ORIGINATION FORM

Proposed Revisions to a Standard Plans Index

Index Number: 649-010

Index Title: STEEL STRAIN POLE

STRAIN POLE ASSEMBLY

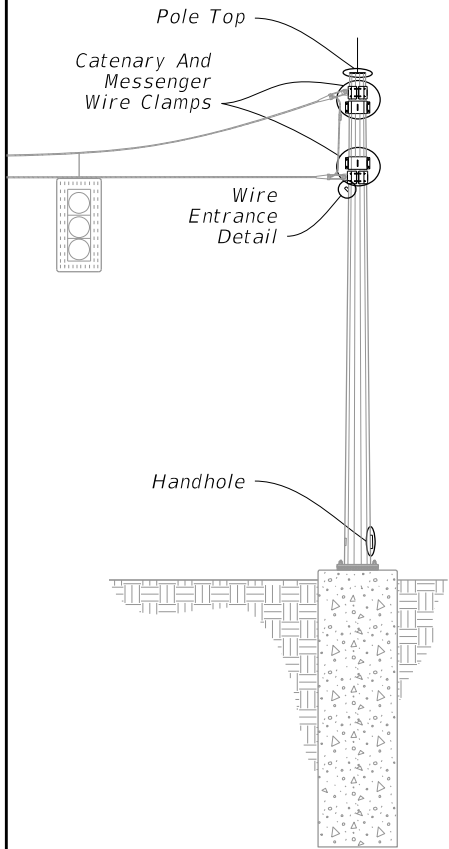
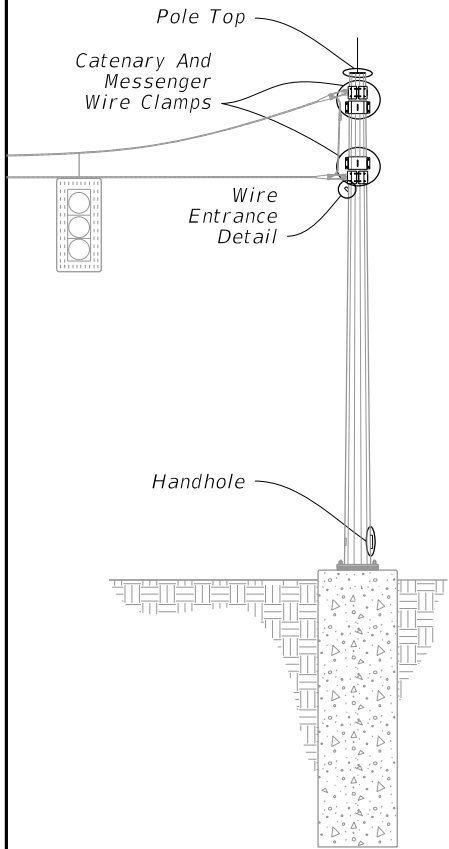
Sheet 1: Changed phrase from "full-penetration groove" to "complete joint penetration".

Sheet 1: Changing non-standard language to standard language consistent with AWS.

H. Fabricate longitudinal seam welds in pole with 60 percent minimum penetration or fusion welds except, within 6" of the base plate connection use full-penetration groove welds.

H. Fabricate longitudinal seam welds in pole with 60 percent minimum penetration or fusion welds except, within 6" of the base plate connection use complete joint penetration welds.

HANDHOLE

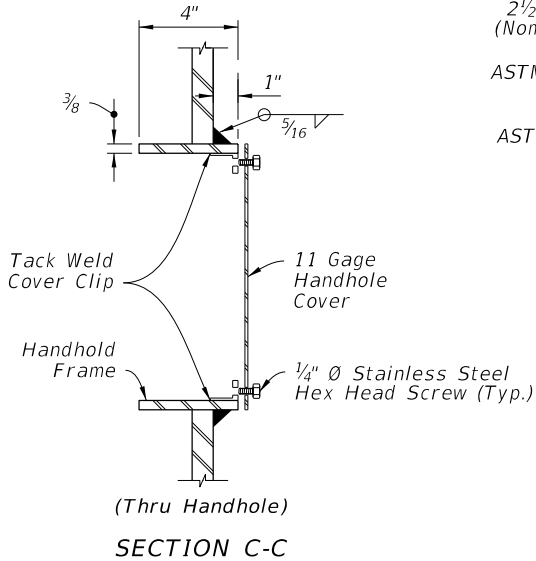
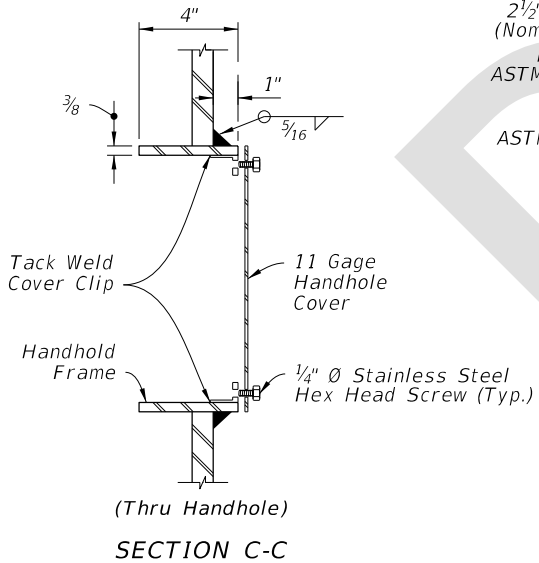
Sheet 3: Changed weld detail to say "CJP."

Sheet 3: Changing non-standard language to standard language consistent with AWS.
